PART D – SHIRE OF MURRAY

Part D – Item 3.1 - Lots 401, 154, 155 (578, 580, 590) Pinjarra Road, Furnissdale – Mixed Commercial Development

Form 1 – Responsible Authority Report (Regulation 12)

DAP Name:	Metro Outer	
Local Government Area:	Shire of Murray	
Applicant:	Apex Planning	
Owner:	Furnissdale Management Pty Ltd	
Value of Development:	\$16.16 million ☐ Mandatory (Regulation 5) ☒ Opt In (Regulation 6)	
Responsible Authority:	Shire of Murray	
Authorising Officer:	Rod Peake – Director Planning and Sustainability	
LG Reference:	P086/2026	
DAP File No:	DAP/26/03077	
Application Received Date:	6 March 2026	
Report Due Date:	29 May 2026	
Application Statutory Process Timeframe:	90 Days (with an additional 35 days agreed)	
Attachment(s):	1. Planning Report and Appendices Appendix A – Certificate of Title. Appendix B – Updated Development Plans. Appendix C – Landscape Plan. Appendix D – Traffic Impact Assessment. Appendix E – Concept Stormwater Management Plan. Appendix F – Bulk Earthworks Plan. Appendix G – Site and Soil Evaluation. Appendix H – Acoustic Assessment. Appendix I – Bushfire Management Plan. Appendix J - Signage Assessment 2. Summary of Public Submissions. 3. Design Re

Figure 6. Previously approved location of service station pylon sign

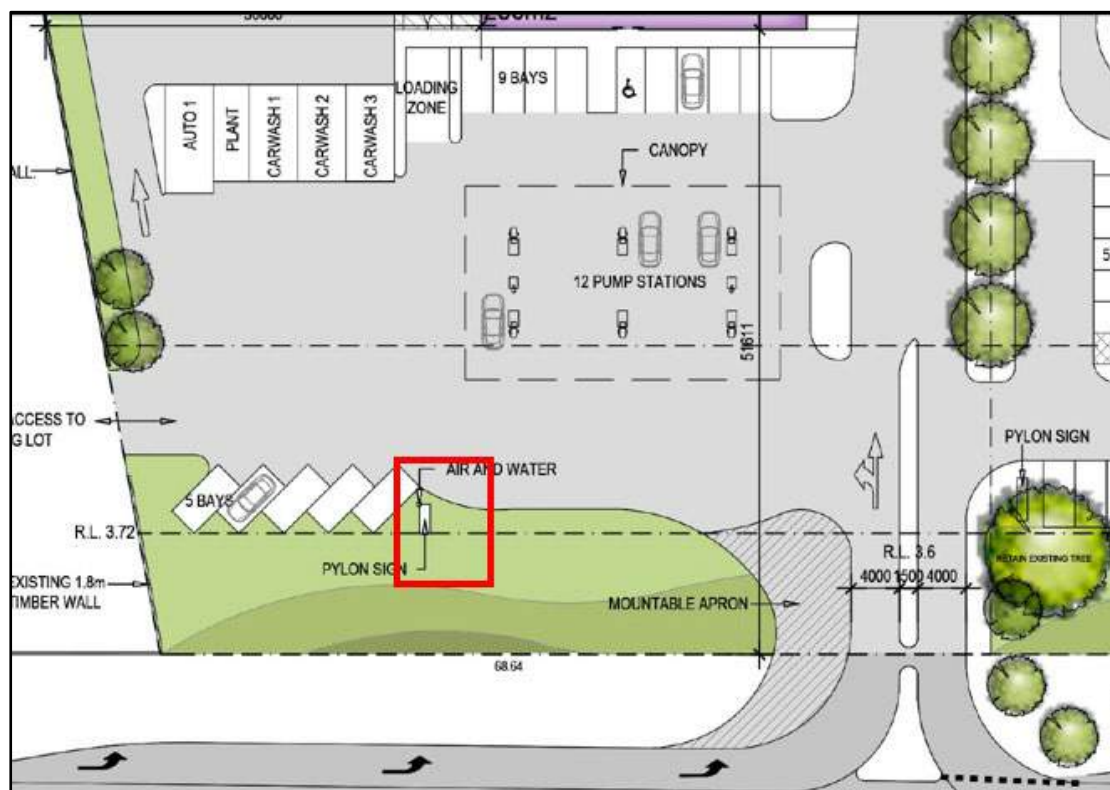
The previously approved service station signage was approved further east (**Figure 6**), closer to the angled parking bays. The Shire's Signs – Local Planning Policy requires at least a 40m from another pylon sign on either the same or adjacent site. The Shire recommends relocating the proposed Service Station pylon sign to the previously approved location, which would meet the policy requirement. The proposed 11m pylon sign abutting the LILLO appears to be close to where the previously approved sign was albeit slightly closer to the LILLO. It is recommended that the applicant consult with the Shire of Murray and Main Roads Western Australia to refine the design of the pylon sign to the west of the LILLO (Condition 21).

Figure 7. Location of sign to be receded in height

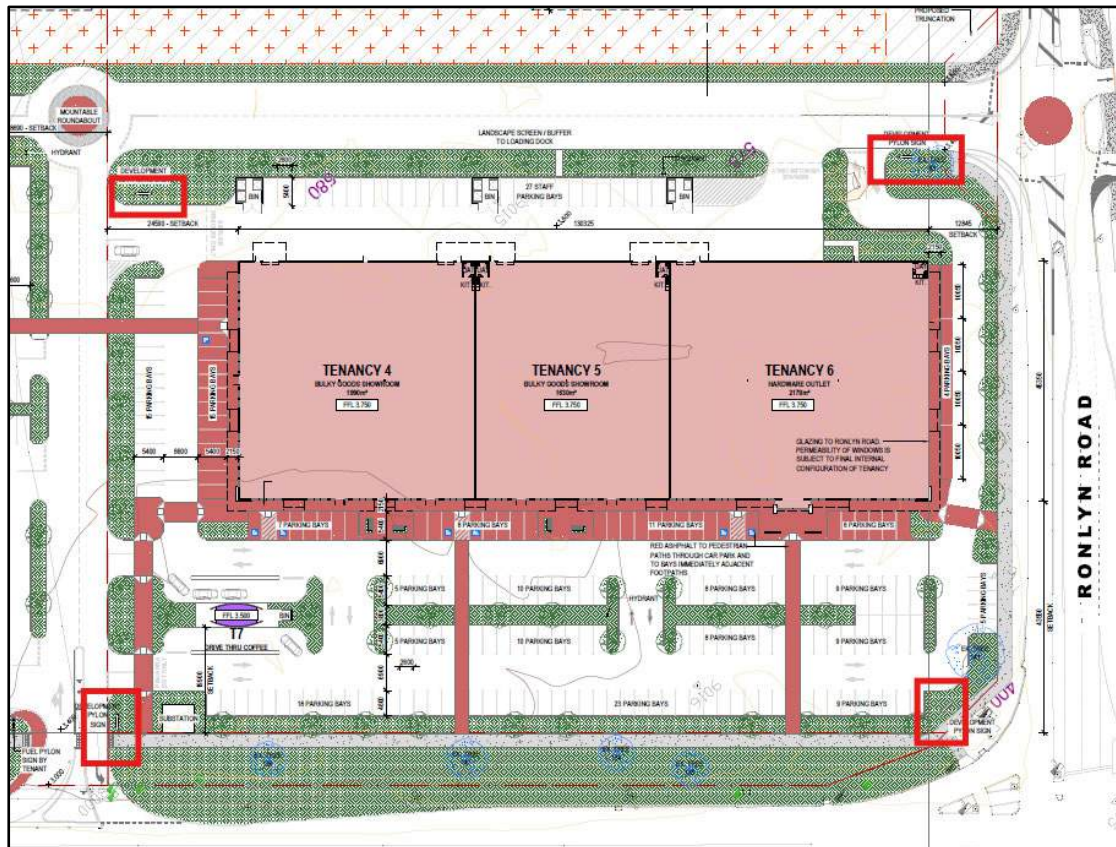
Condition 39 of the original DAP required the 10m to 11m angled pylon sign fronting Ronlyn Road to be reduced to 6m (**Figure 7**). This was on the basis that Ronlyn Road is a future Mainstreet with a local neighbourhood commercial centre. It is recommended that this condition be carried forward (Condition 17). The Shire notes that there was no sign previously on the internal access road in the location shown in **Figure 8**. It is recommended that this also be reduced in height to match the signage fronting Ronlyn Road.

DRAWING NO. A9.01		REVISION: B
JOB NO: 163	SCALE: NTS	NORTH:
DRAWN BY: YN	CHECKED BY: YN

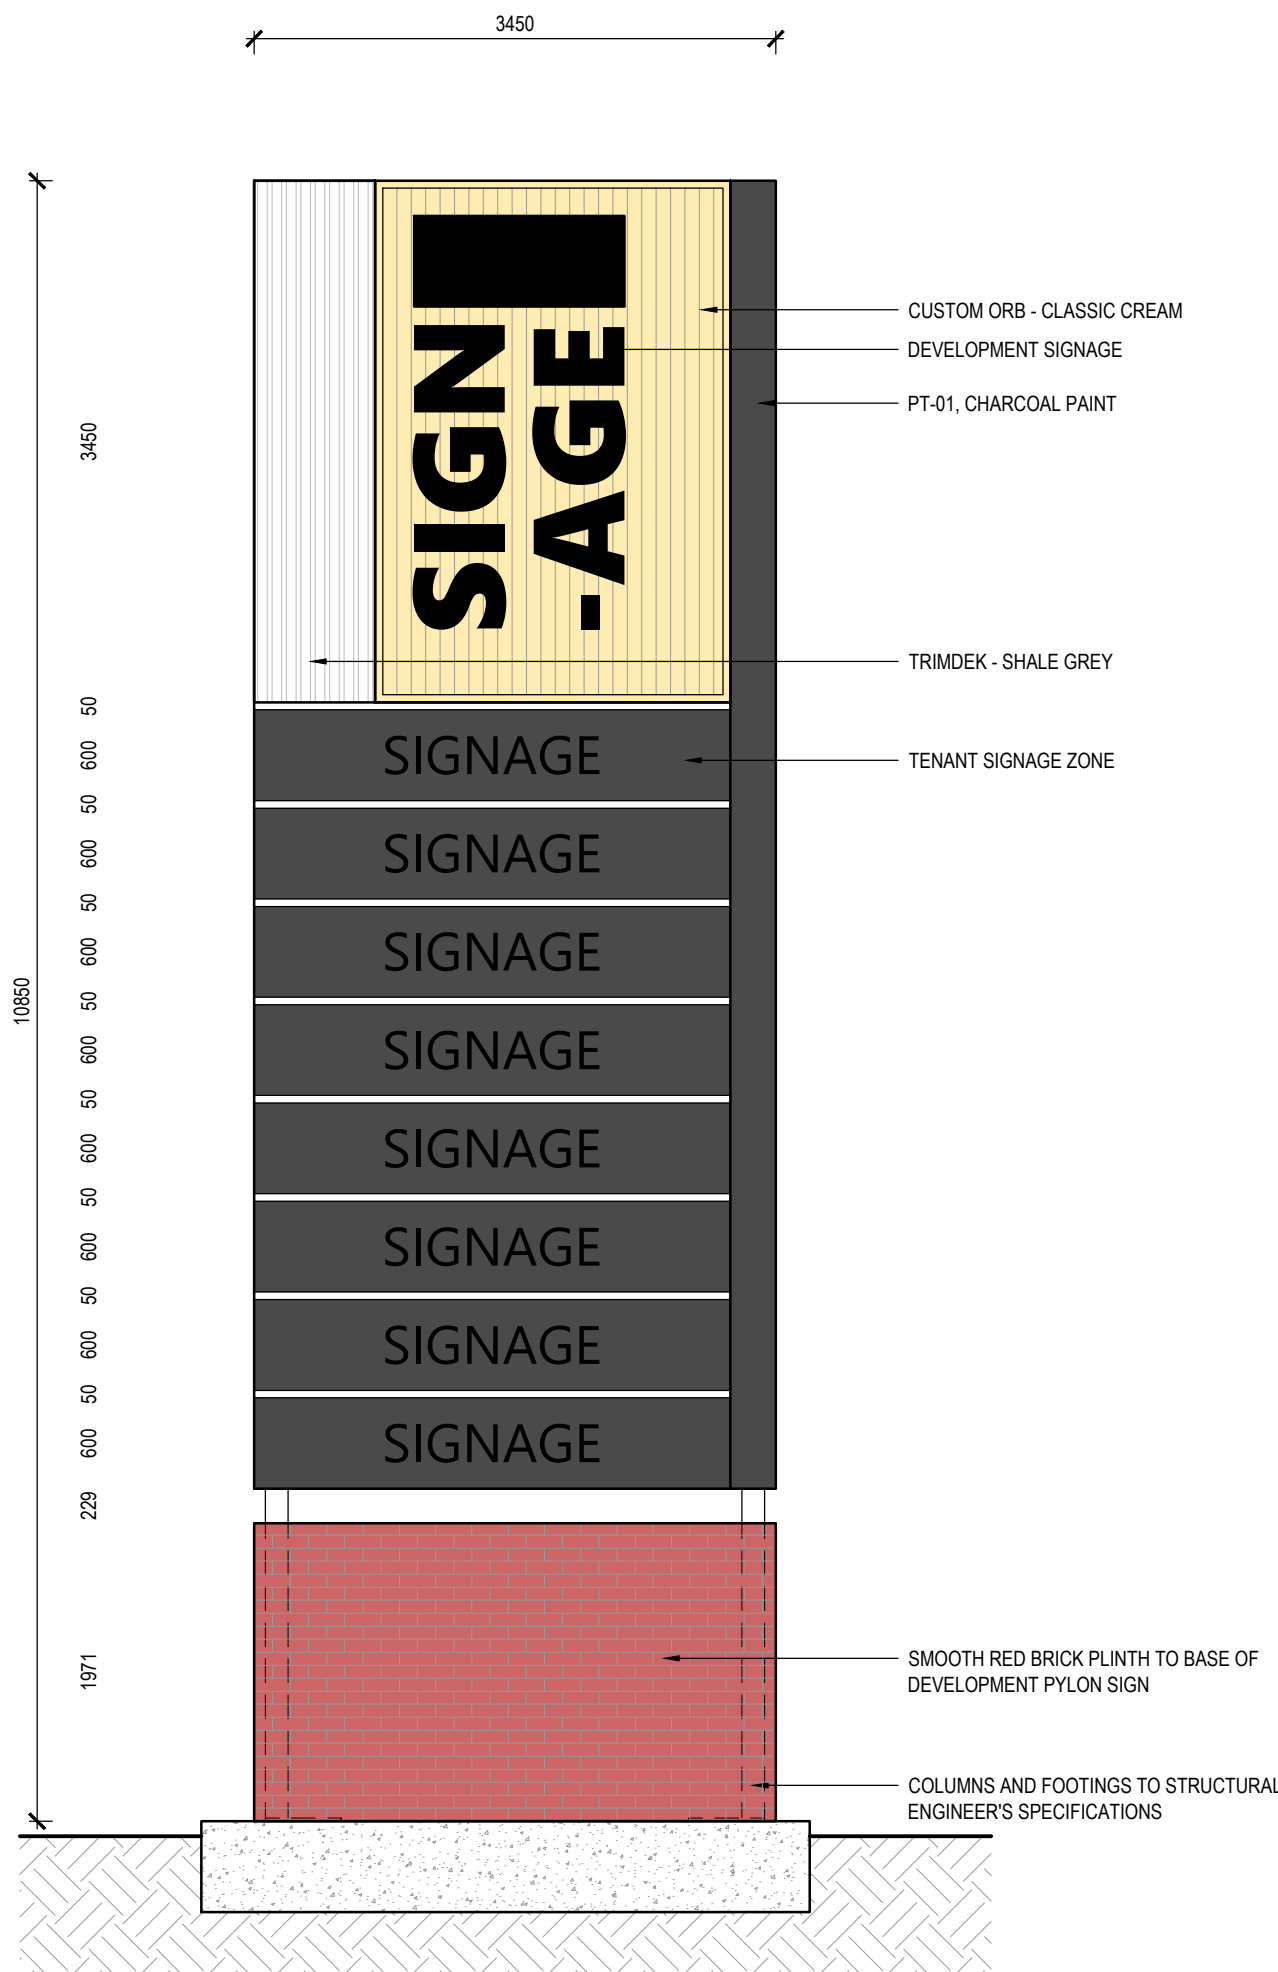
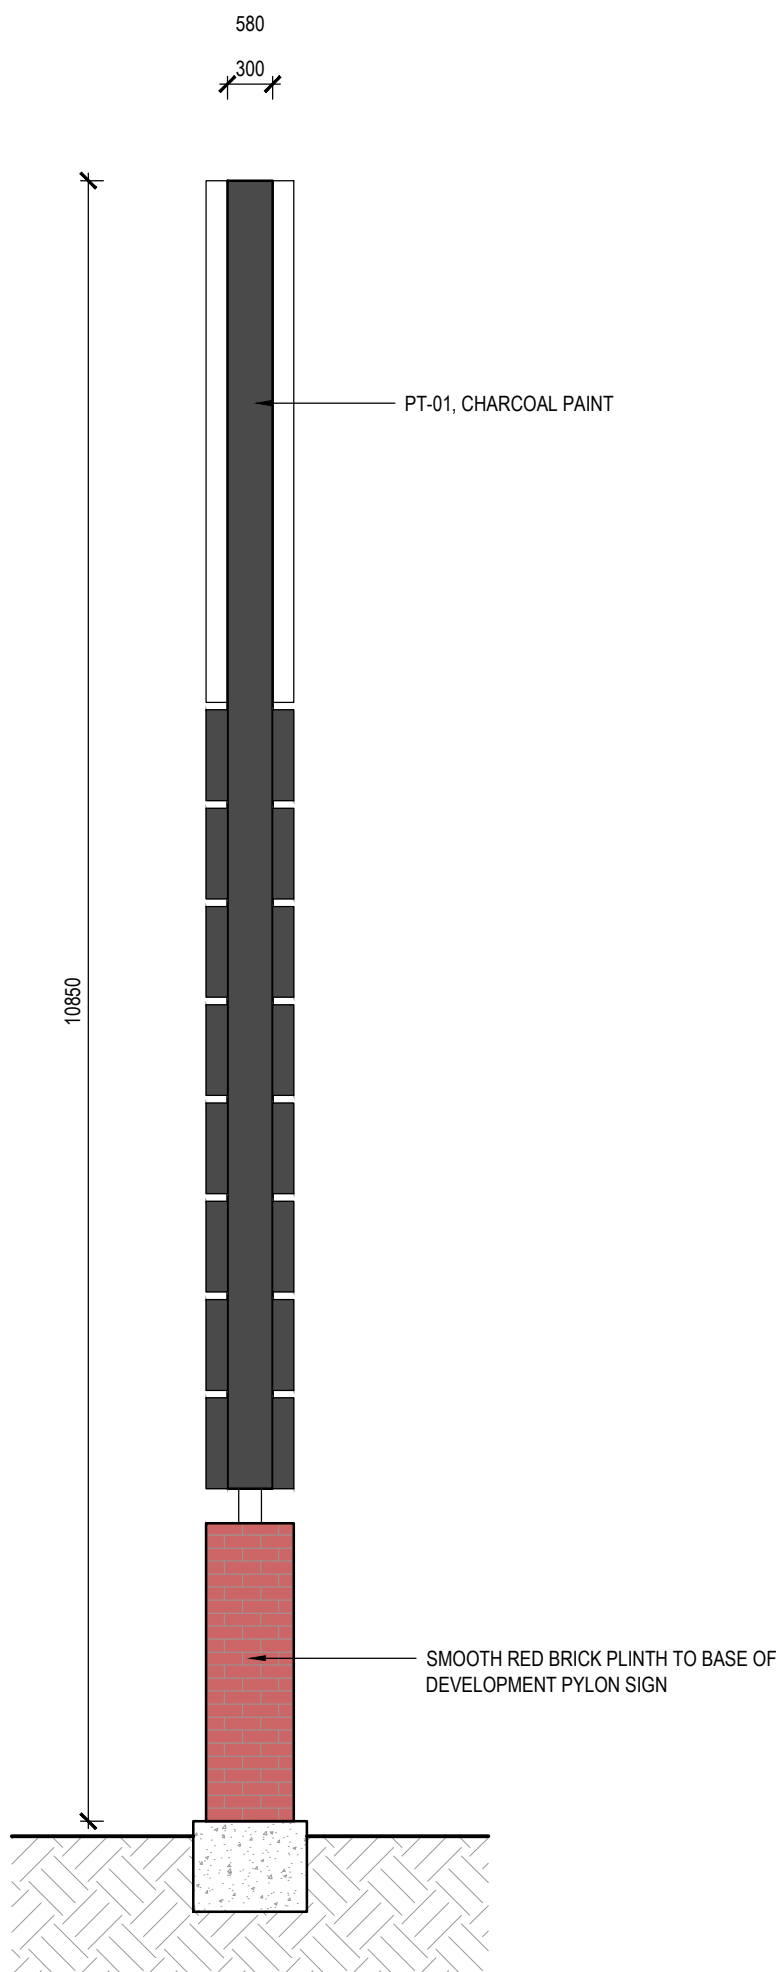
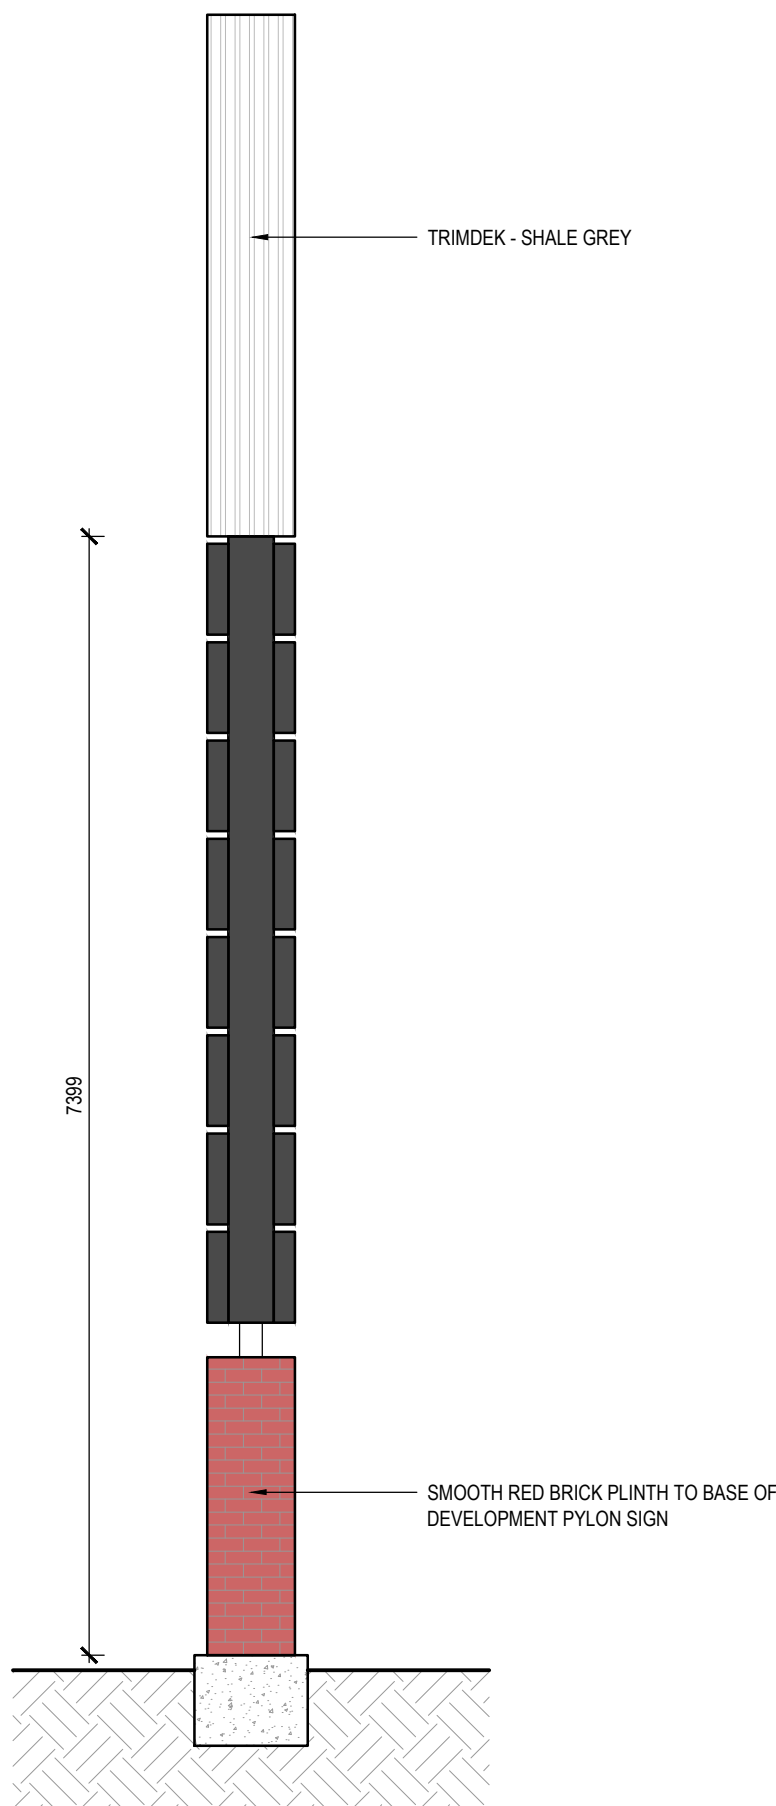
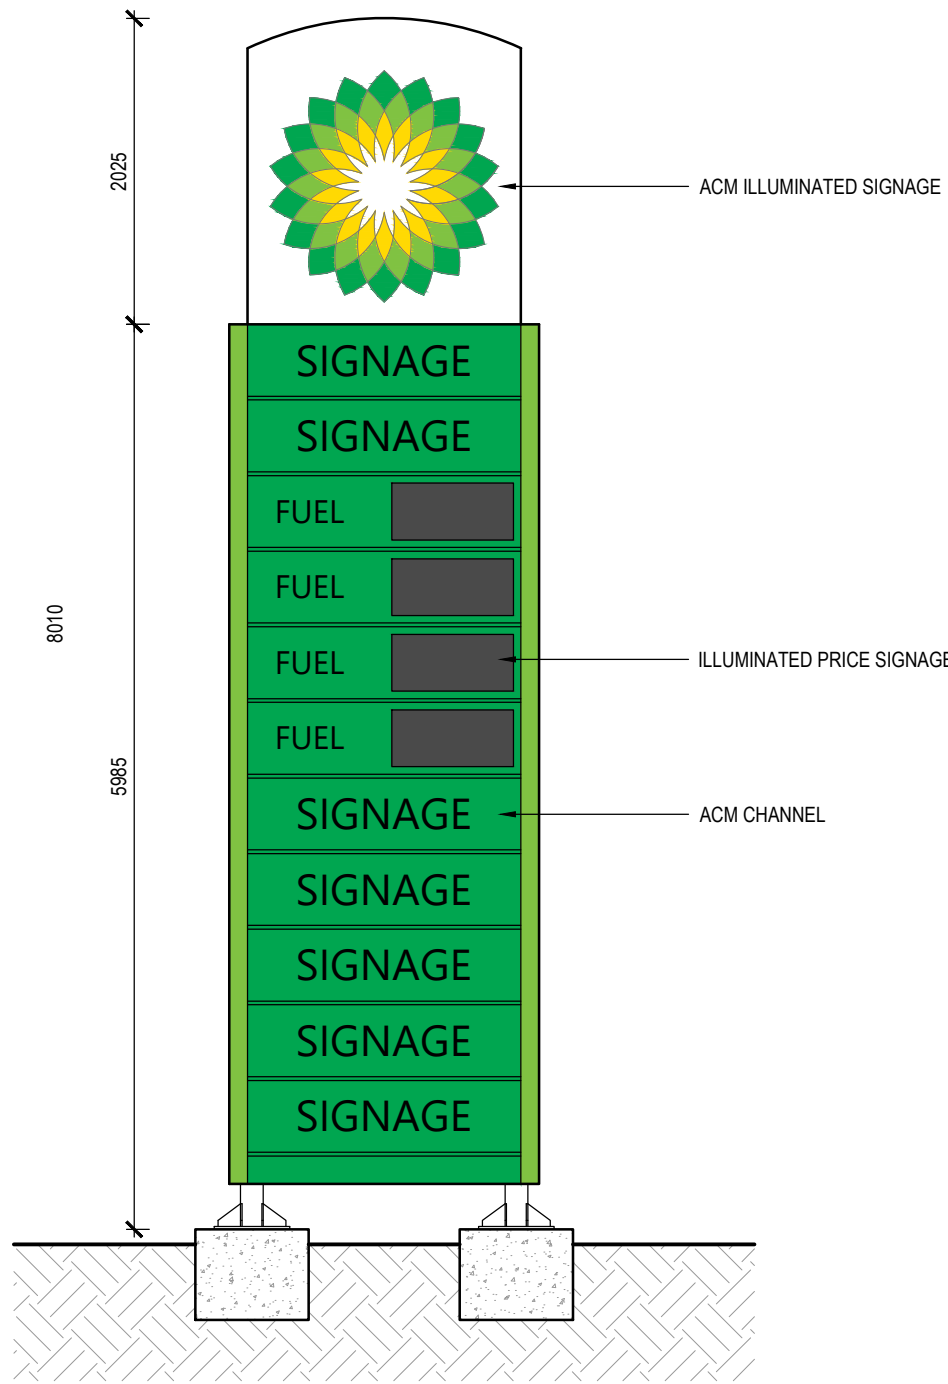
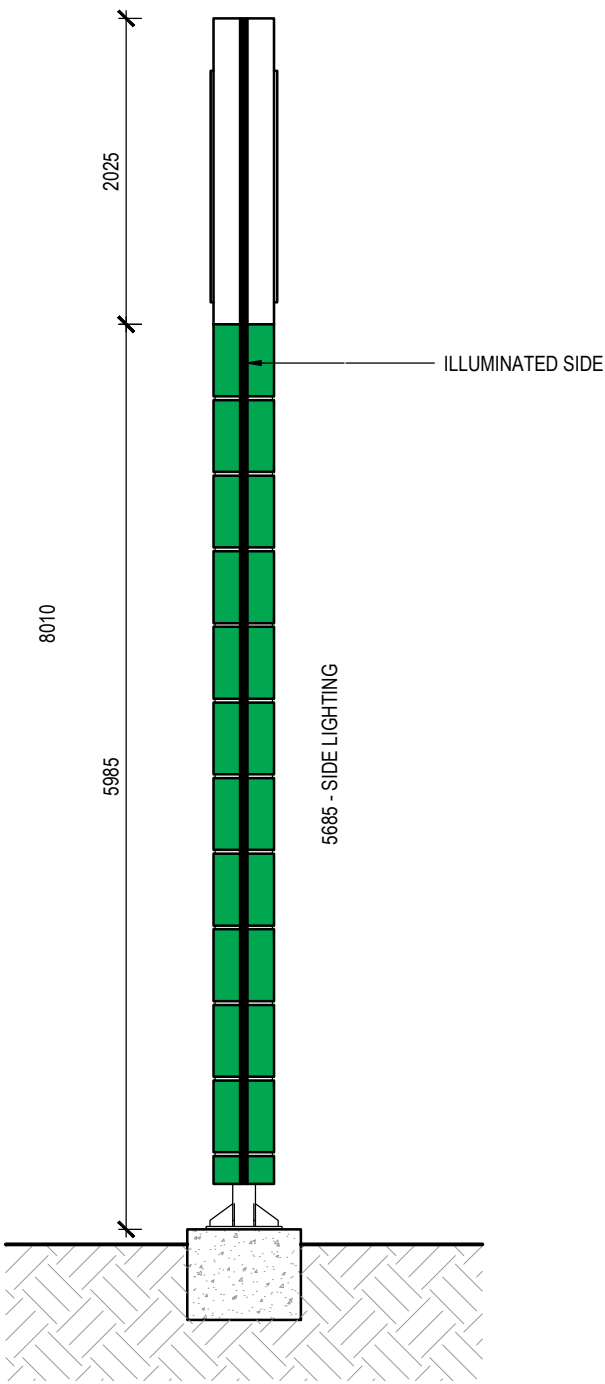
The proposed pylon sign for the service station is 8.01m. The 4 identical pylon signs are all 10.85m. The applicant has provided an assessment of the sight lines.
